DFCM Addendum #3

Reference: Bastian Equestrian Arena
DFCM Project #25401770
U3P Event #CS25039-Stage II

ADDENDUM NO. 1
April 14, 2025

USU Bastian Equestrian Arena

Project #: 24.0170
 Date: JANUARY 31, 2025
 Provisions :
 Final Bid Addendum 4-15-25

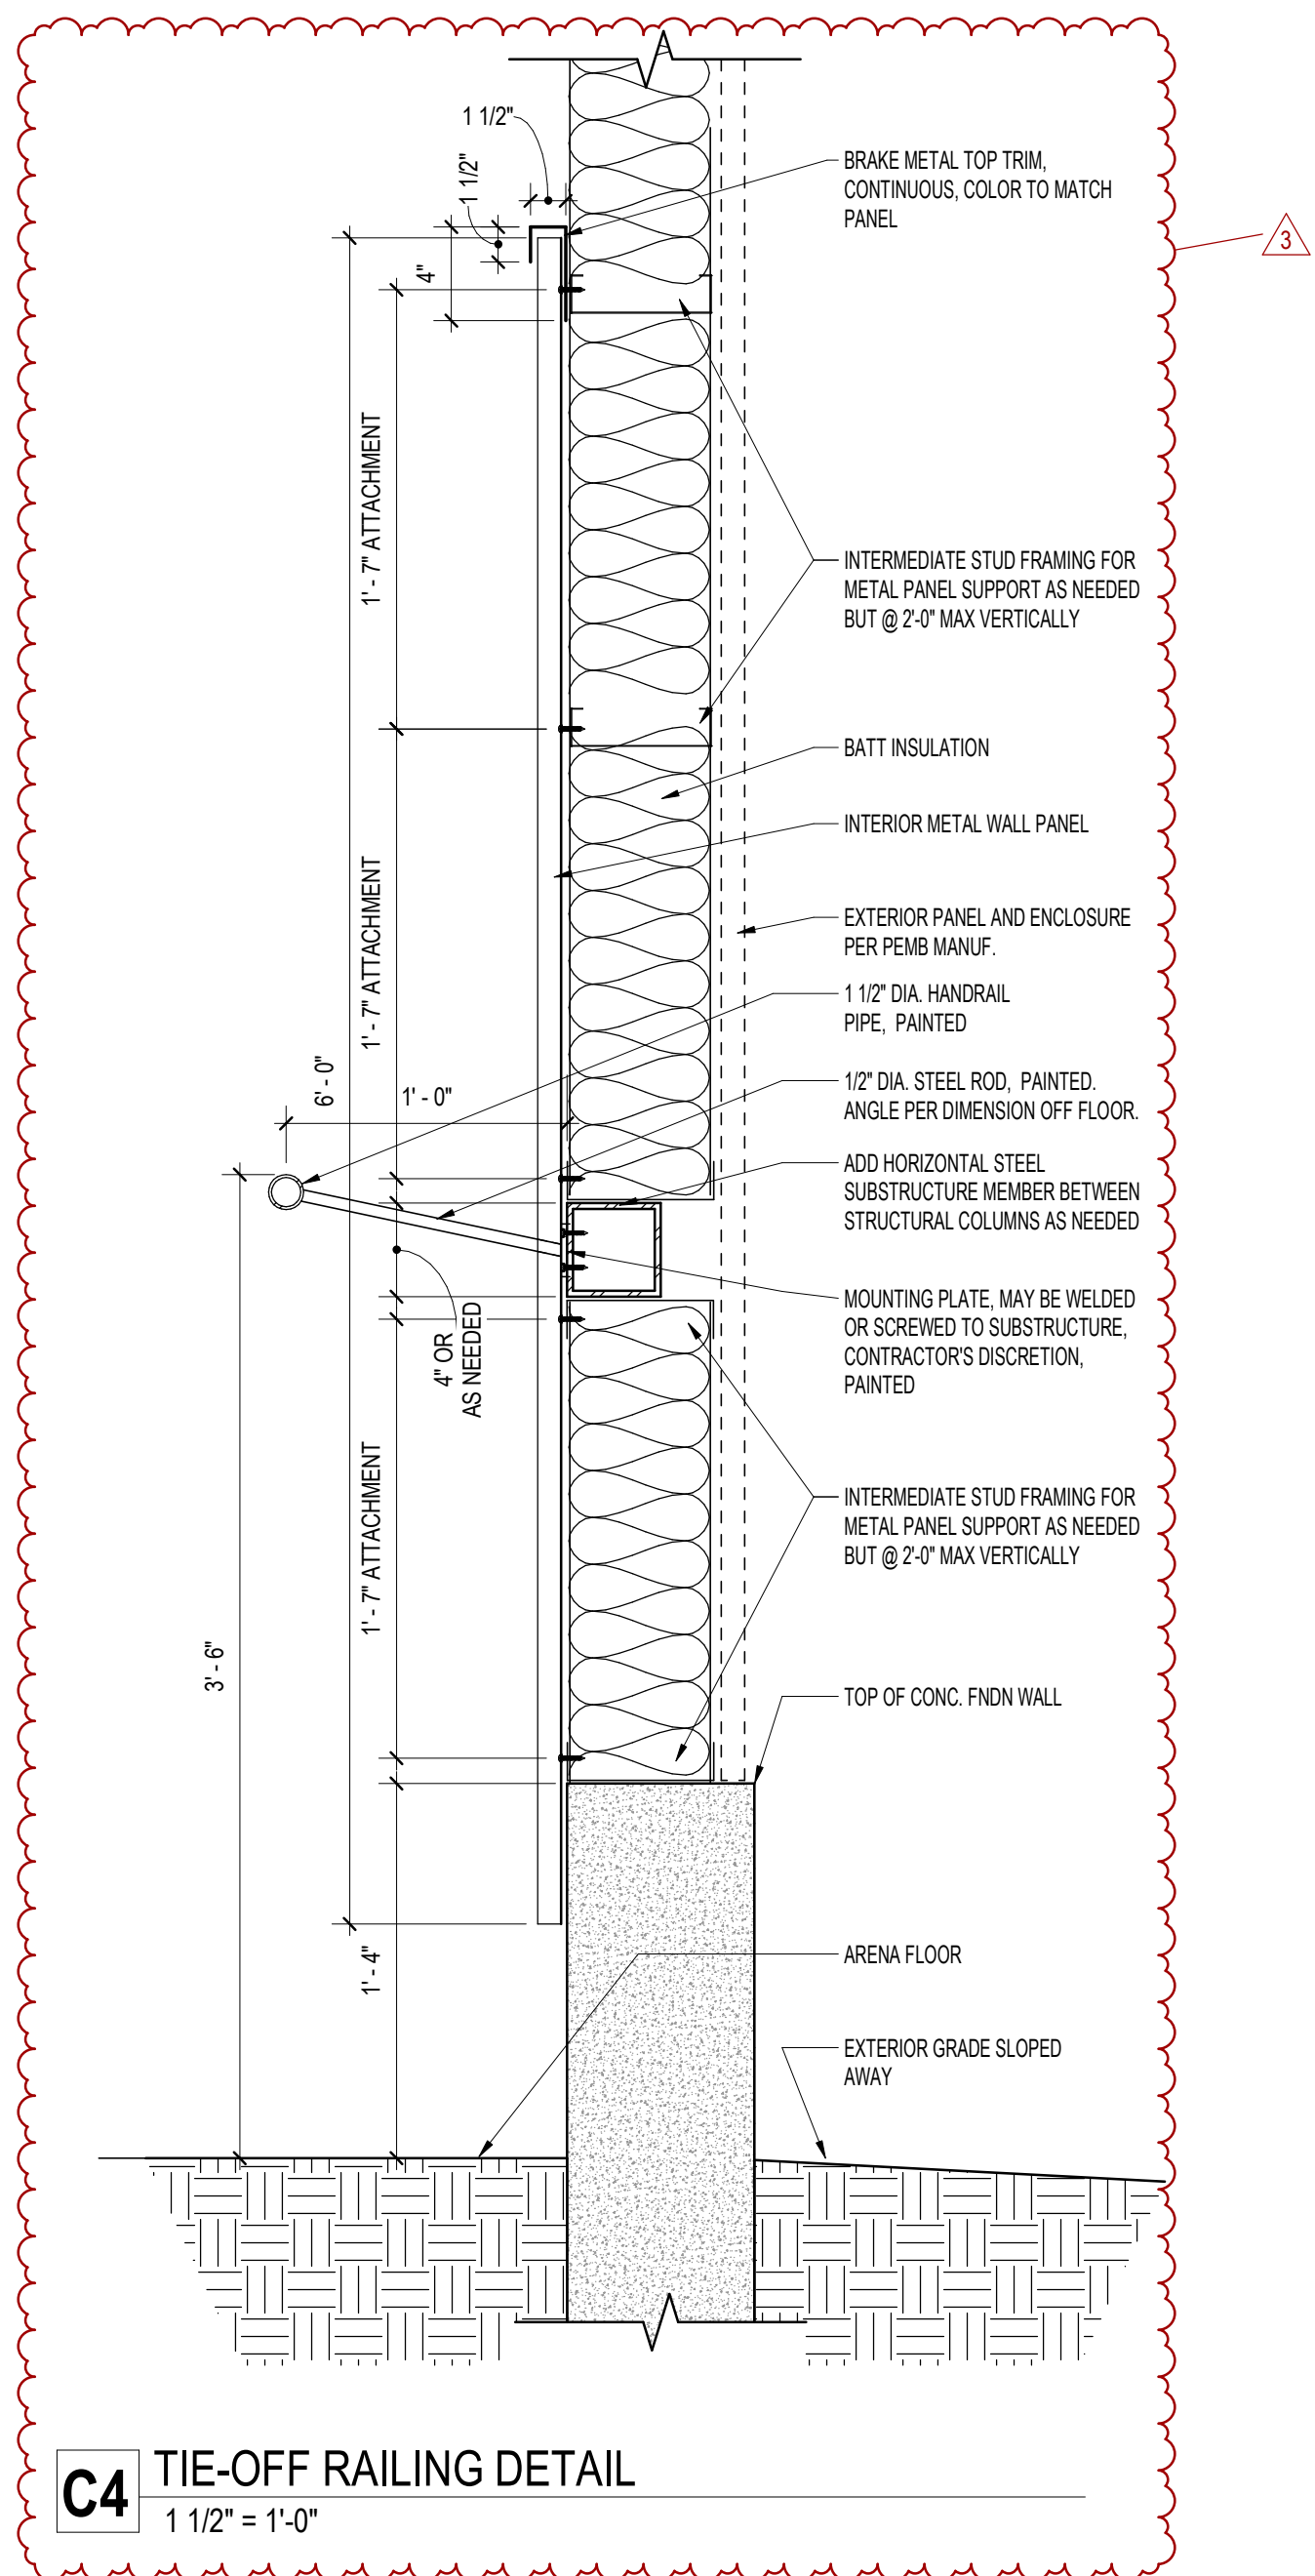
Question 003 - C201 – keynote 7: coordinate location of frost-free hydrants relative to adjacent bollards. Provide bollard detail

Question 023 - 6" curb around railing – Wall type CU8 (concrete wall) shows only at booth, the intent appears to be all around for arena railing – please confirm limits of concrete wall?

Question 024 - Tie Rail – keynote 05.09 indicates detail on elevation. Please provide detail as no detail is shown on elevation.

Response: Provide frost-free hydrants per locations and number shown on C201. Bollard locations and detail have been updated and added to architectural plan A101 and A511.

Response: The CU8 wall type is shown only on the 3 sides of the audience area slab, not at the announcer's booth. The permanently installed arena railing should be installed in the CU8 wall type per detail A5/A511. Any other arena railings shown are all moveable railings depending on the event happening in the arena.

Response: A new detail has been added to the drawings for this tie rail ON C4/A511 and called out on the interior elevations for the arena on sheet A213. See clouded drawings.
